## **Proposal for amendments to document ECE/TRANS/WP.29/2025/7**

### **Proposal for the new 01 series of amendments to UN Regulation No. 171 (Driver Control Assistance Systems)**

The text reproduced below was prepared by the experts from Task Force on Advanced Driver Assistance System (ADAS) to update the draft 01 series of amendments to UN Regulation No. 171. The modifications to the text of the mentioned document are marked in bold for new characters and in strikethrough for deleted characters. The dates indicated in the Transitional Provisions remain in the square brackets, still the subject of final decision by GRVA. **Additional corrections are provided in response to the comments made by GRVA experts at the 21<sup>st</sup> GRVA session. The dates in the transitional provisions are changed according to the agreement reached in the course of the 21<sup>st</sup> GRVA session.**

*Paragraph 4.2.5.2.8.1.2., amend text and update diagram to read:*

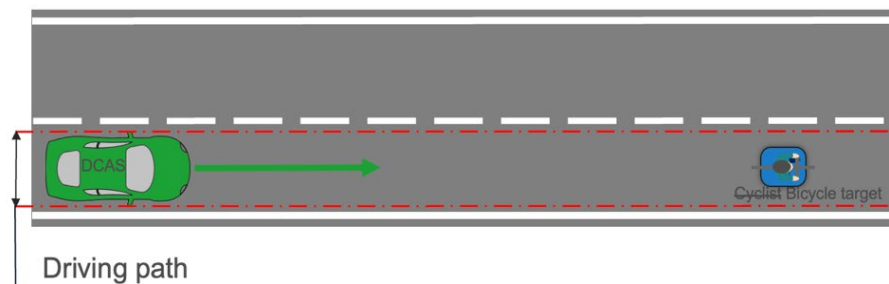
- “4.2.5.2.8.1.2. The VUT shall approach the impact point with the ~~bicycle cyclist~~ target in a straight line for at least two seconds prior to the functional part of the test.”**

9. Paragraph 2.1. in Definitions is updated to amend a grammatical correction.
10. In Test procedures, cyclist is amended to bicycle in paragraph 4.2.5.2.8.1.2. because this reference specifically relates to the object and not the rider of the bicycle. The text in the corresponding diagram is updated from Cyclist to Bicycle to align with the terminology in the text.
11. The diagram in paragraph 4.2.5.2.10.1.1. contains text which has been updated from Cyclist to Bicycle to align with the terminology in the text.
12. Paragraph 4.2.5.2.12.1.1. is amended for clarification and accuracy. The corresponding diagram is updated from Cyclist to Bicycle to align with the terminology in the text.

Paragraph 4.2.5.2.10.1.1., update text in diagram to read:

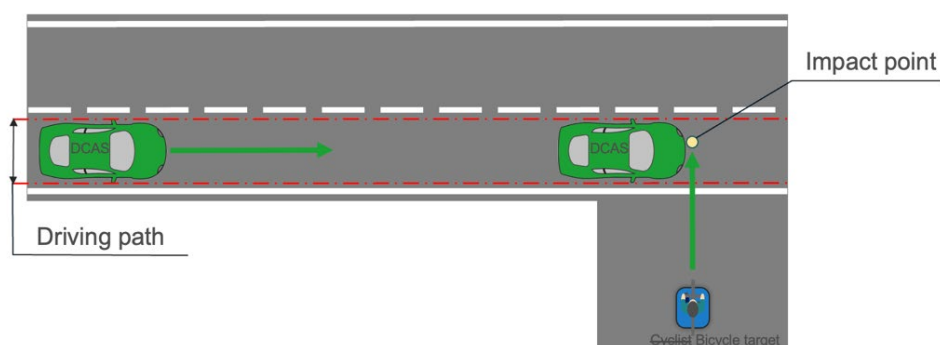
“4.2.5.2.10.1.1. The bicycle target shall travel in a straight line perpendicular to the VUT’s direction of travel at a constant speed of 15 km/h +0/-1 km/h, starting not before the functional part of the test has started. During the acceleration phase of the bicycle target prior to the functional part of the test the bicycle target shall be obstructed. The bicycle target’s positioning shall be coordinated with the VUT in such a way that the impact point of the bicycle target on the front of the VUT is on the longitudinal centreline of the VUT with a tolerance of not more than 0.2 m, if the VUT would remain at the prescribed test speed throughout the functional part of the test and does not brake.”

Paragraph 4.2.5.2.12.1.1., amend text and update diagram to read:

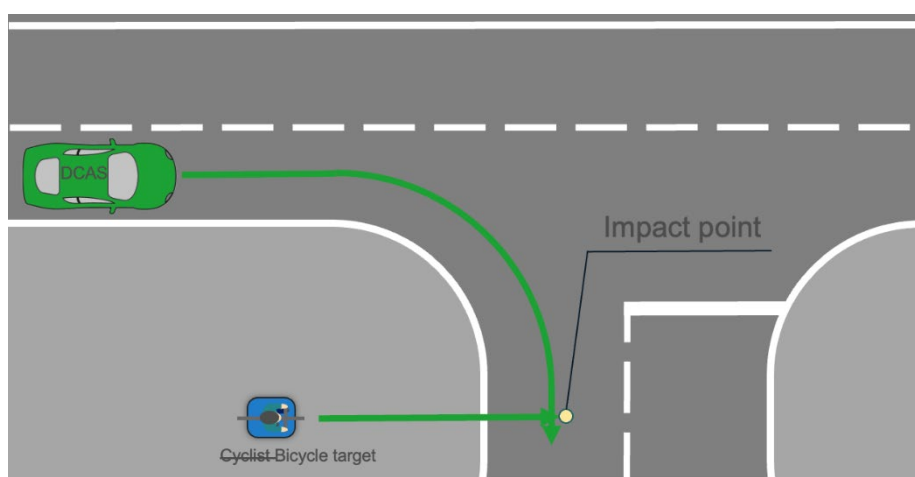
“4.2.5.2.12.1.1. The bicycle target shall travel in a straight line perpendicular to the VUT’s direction of travel at a constant speed of 15 km/h +0/-1 km/h, starting not before the functional part of the test has started. During the acceleration phase of the bicycle target prior to the functional part of the test the bicycle target shall be obstructed. The bicycle target’s positioning shall be coordinated with the VUT in such a way that the impact point of the bicycle target **on the front of the VUT is on the longitudinal** centreline offset of not more than 0.2 m, if the VUT would remain at the prescribed test speed throughout the functional part of the test and does not brake.”
